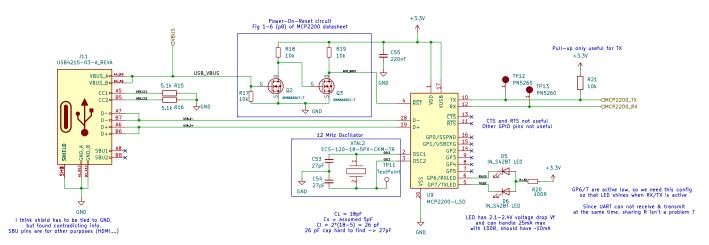
Correct to connect VDDA to VDD ?

"The VDDA voltage level is independent from the VDD voltage and must be connected to VDD (preferably) or to VSS pin when these peripherals are not used." datasheet p29
